**Office of Utility Consumer Counselor
Comments on Duke Energy Indiana's
2021 Integrated Resource Plan**

PPI Commodity Data

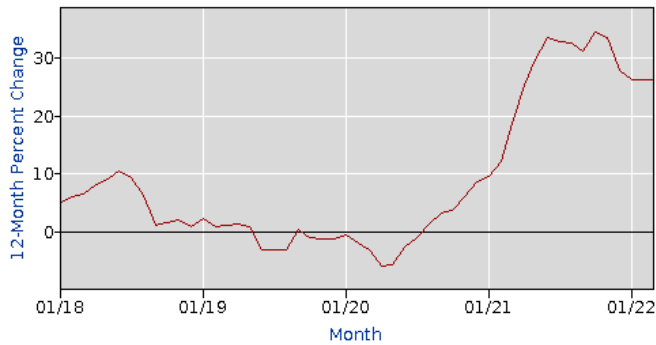
Refer to SEC 5(B)(1-3), AN EVALUATION OF PLAUSIBLE RISK BOUNDARIES OR ALTERNATIVE FORECASTS OF PEAK DEMAND AND ENERGY USE, on p. 161 of DEI's 2021 IRP. The West Texas Intermediate (WTI) crude oil price used in DEI's baseline forecast, \$40 to \$60 per barrel through the end of the 2022, does not align with actual prices. Currently, crude oil prices are significantly higher than the amount DEI used in its modeling. During February 2022, the price per barrel hovered around \$90. This is more than double DEI's \$40 base amount. Although, it was most likely unknown how drastically the price would increase at the time the IRP inputs were decided, by mid-2021 the price per barrel was already above \$60 per barrel, and DEI should have adjusted accordingly. Costs of fuel may be significantly higher than DEI forecasted resulting in a potentially distorted forecast. WTI price continues to fluctuate from approximately \$90 per barrel in January 2022 to approximately \$110 per barrel in April 2022. The price fluctuation is significantly greater than the price range DEI identified. Commodity indices for non-ferrous metals wire and cable, steel, transformers, and regulators have increased by 30% since mid-2021. The graphs below depict fluctuations in oil and commodities.

Current WTI crude oil and commodity prices coupled with inflation could indicate changed preferred portfolio outcomes in DEI's IRP.
